Architect's Supplemental Instructions

Architect's ASI No: 024

Project:
Webster University
Interdisciplinary Science
Building

Description: ASI – 024 (RFI-222, 233, 235 & 236)

P0011

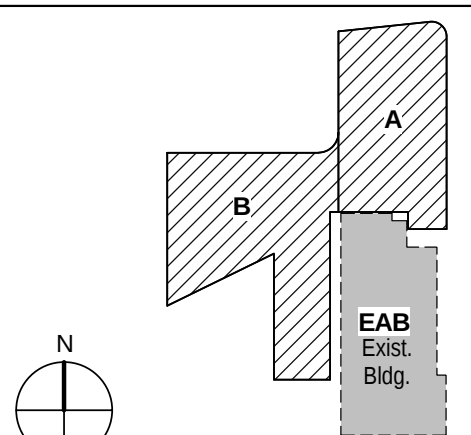
RFI-222, (P0011 & P0111.A); Provide and install 4" CI Standpipe 2 feet above finish floor for sprinkler system drainage. Refer to sheets P0011, P0101.A & P0111.A.

P0101.A

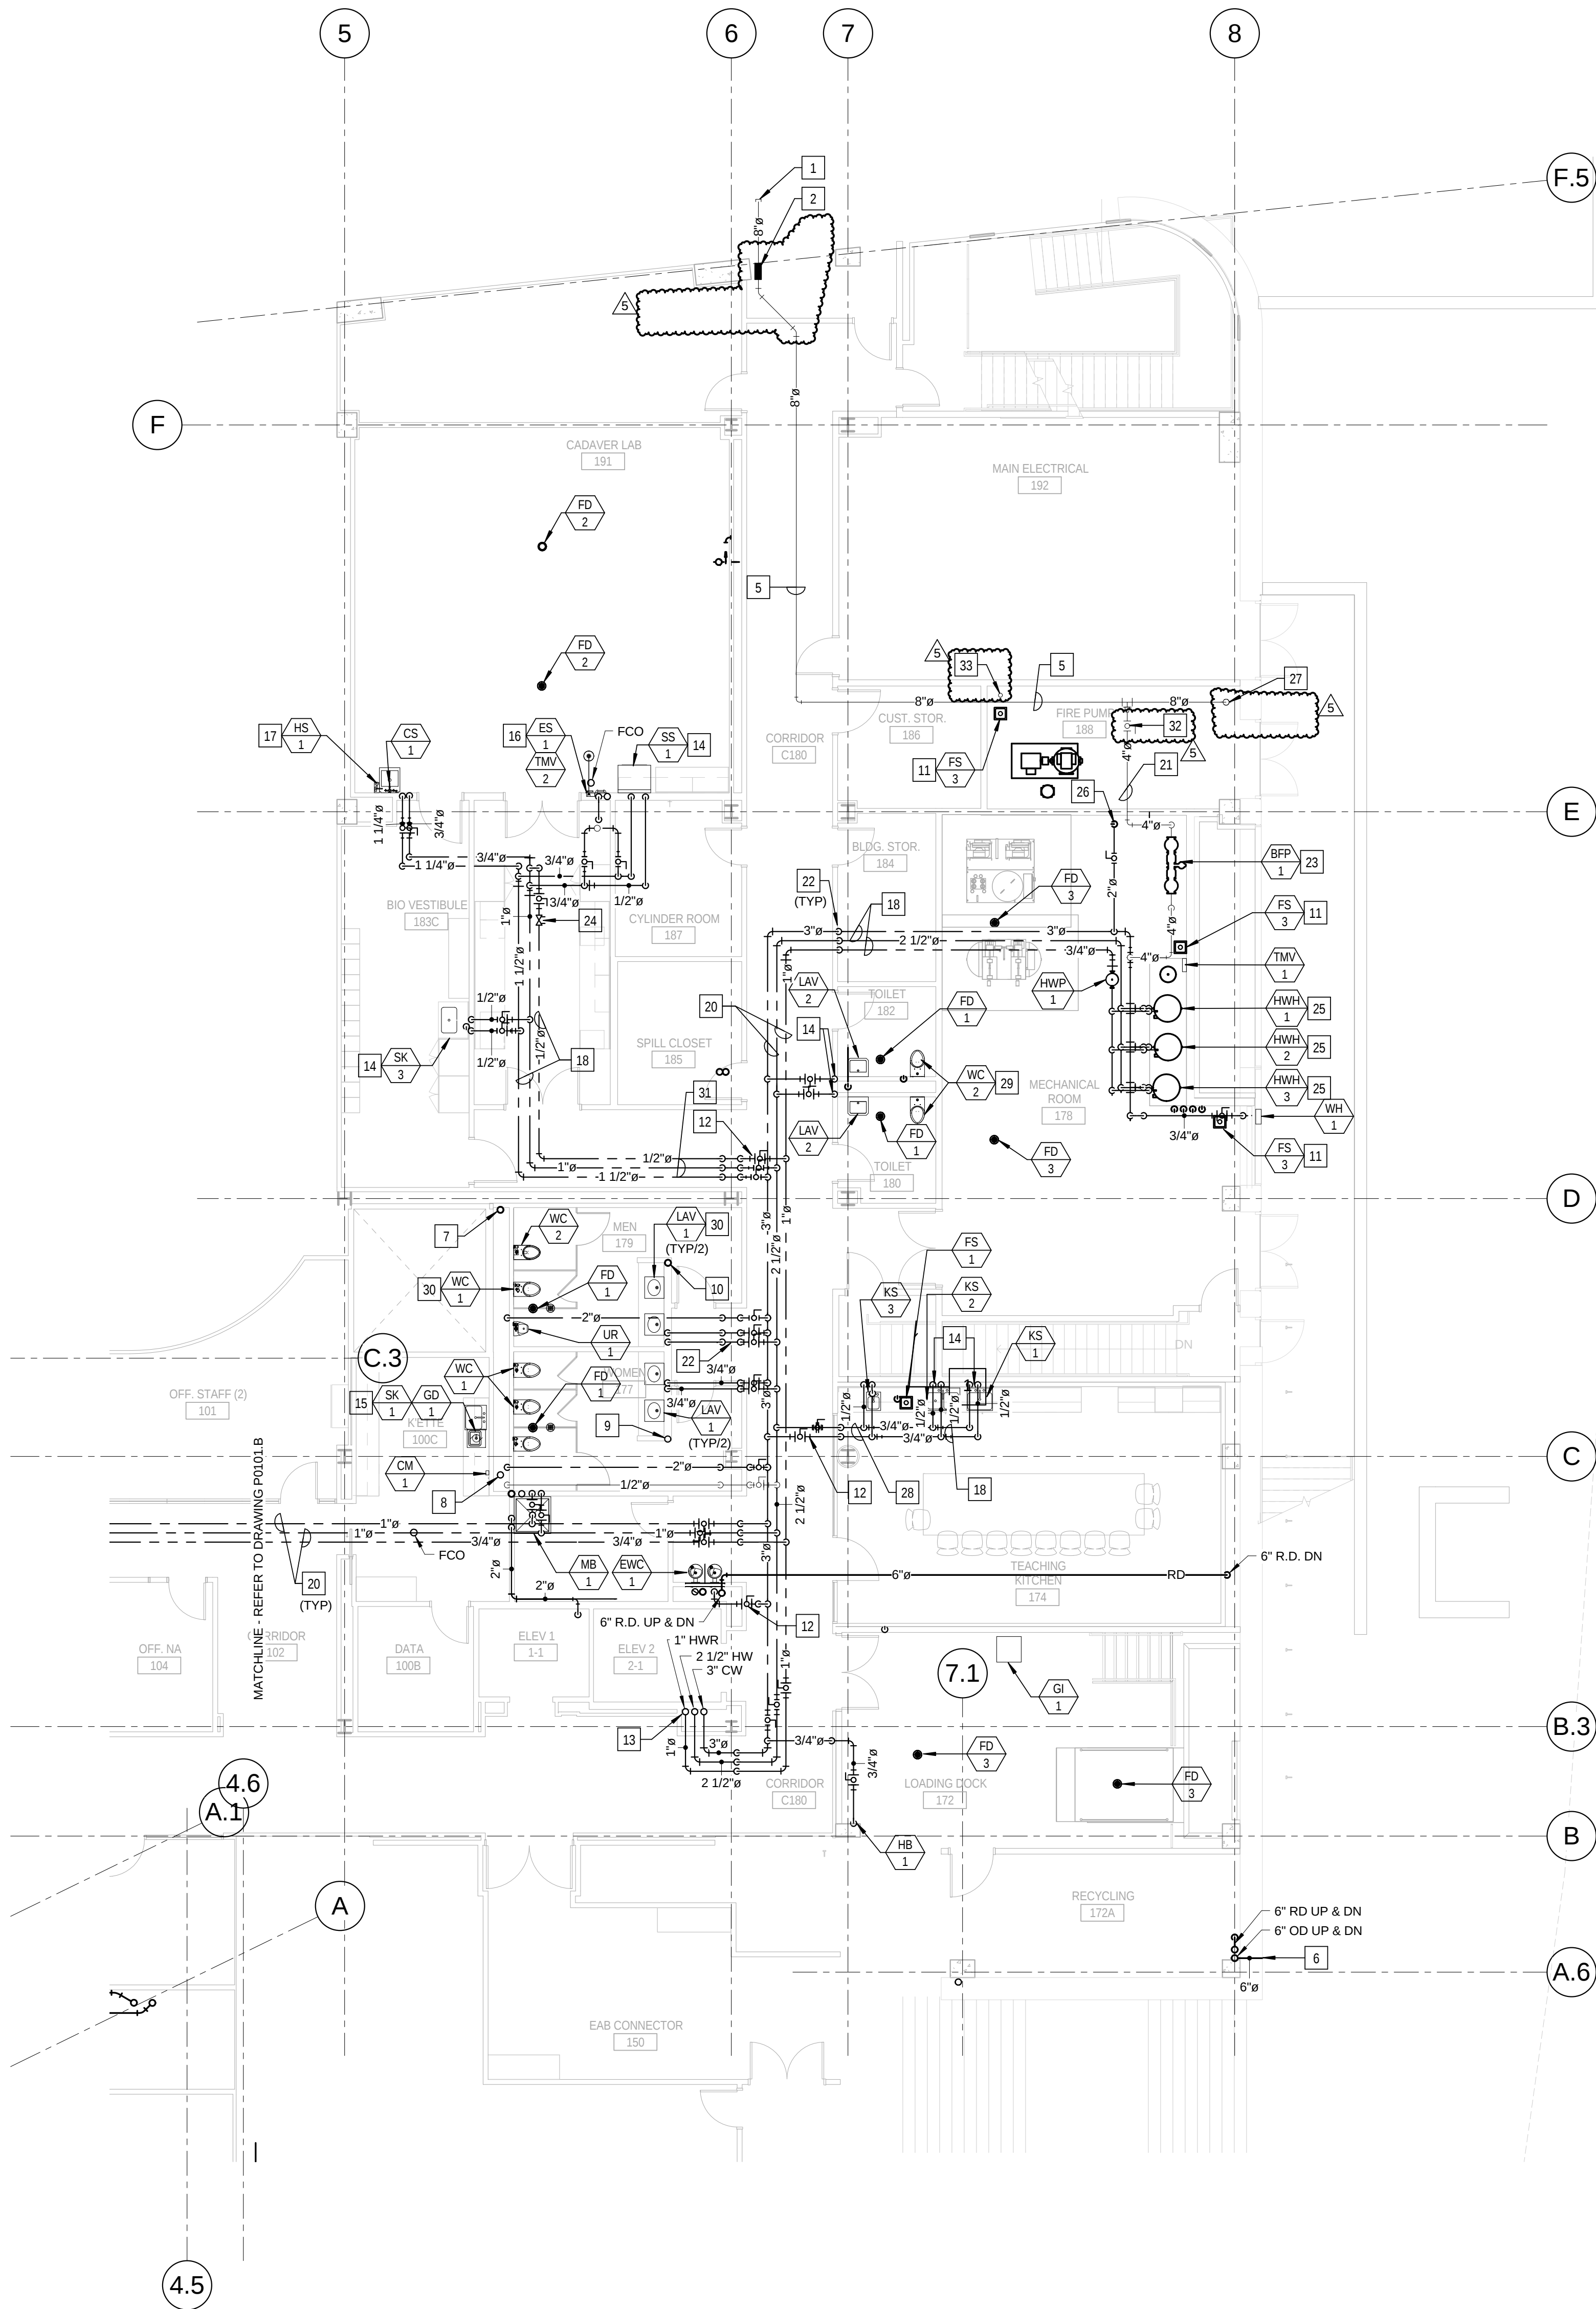
RFI-235, (P0101.A & P0403); Revise 8-inch combination fire and domestic water service as noted. Remove 8-inch building service valve as indicated. Install new 4-inch domestic valve on 4-inch domestic service line as shown on drawings P0101.A and riser diagram sheet P0403. Relocate pressure gauge as indicated on plans.

P0104.A

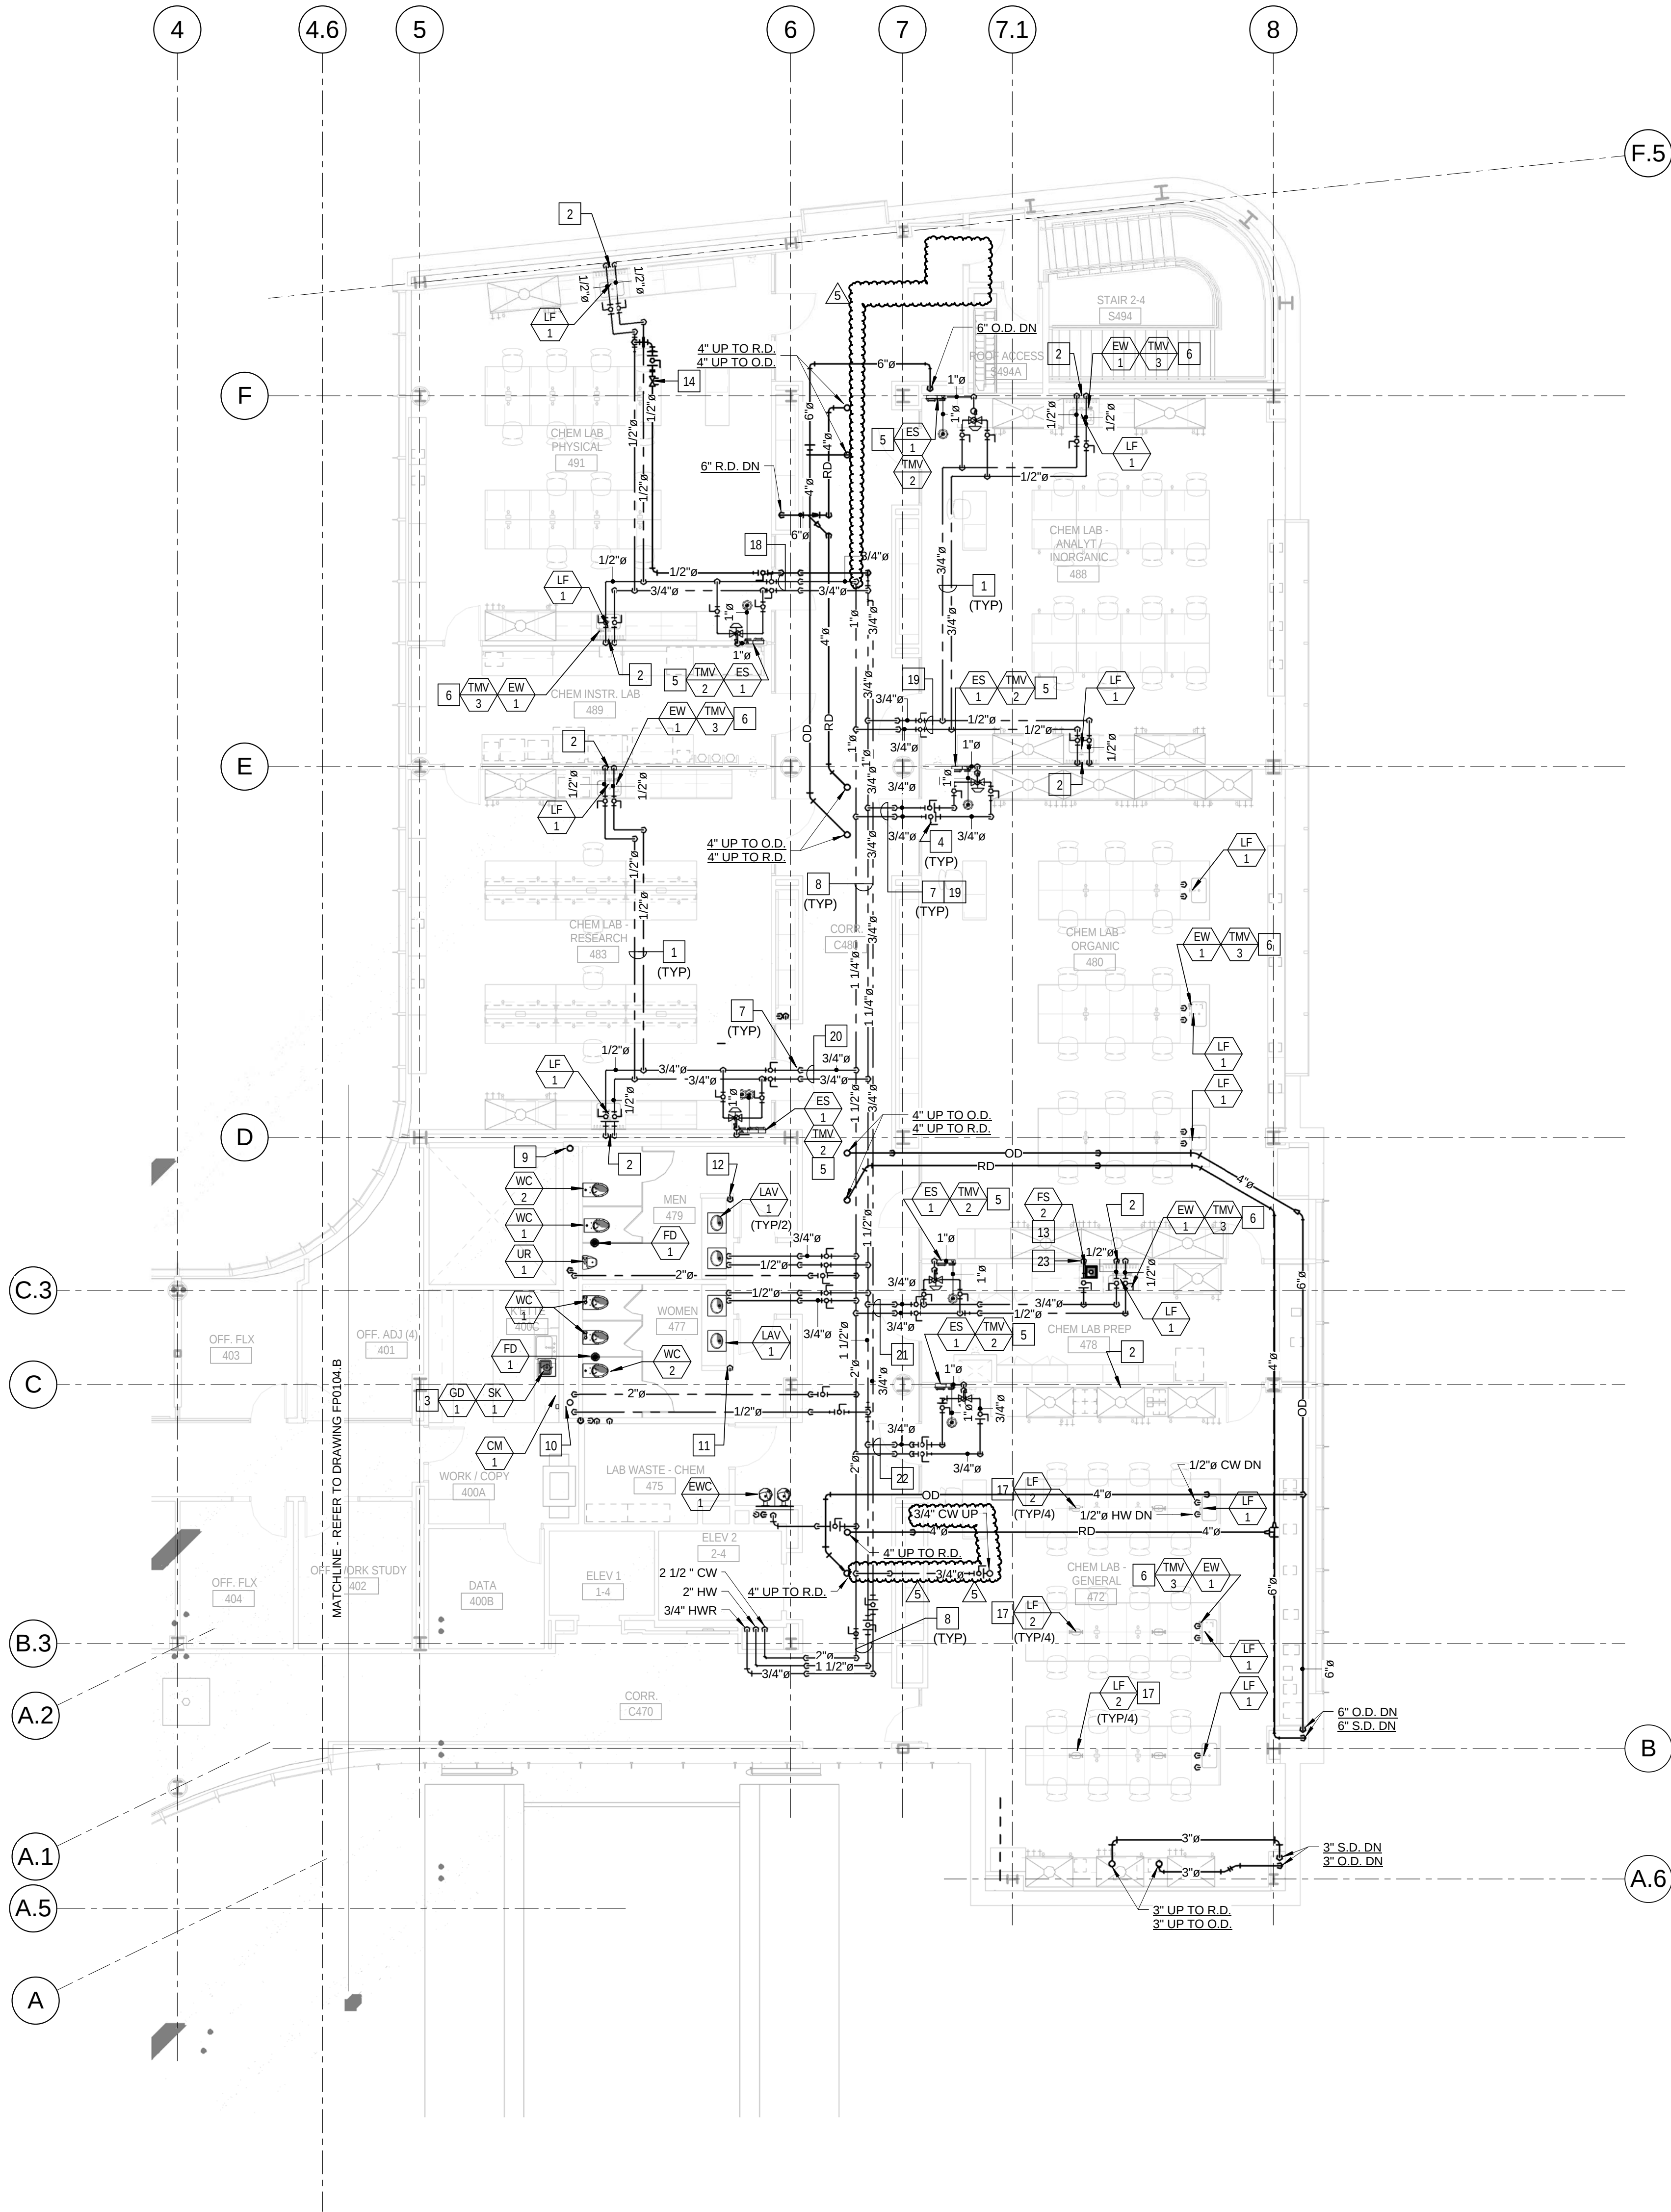
RFI-236, (P0104.A, P0111.A & P0105.A); Provide and install ¾" CW service up through roof to serve Non-Freezing Sanitary Roof Hydrant, Jay R. Smith model 5903 or equal. Refer to sheets P0104.A, P0111.A and P0105.A for all changes. Coordinate exact location of hydrant with Architect prior to rough-in.
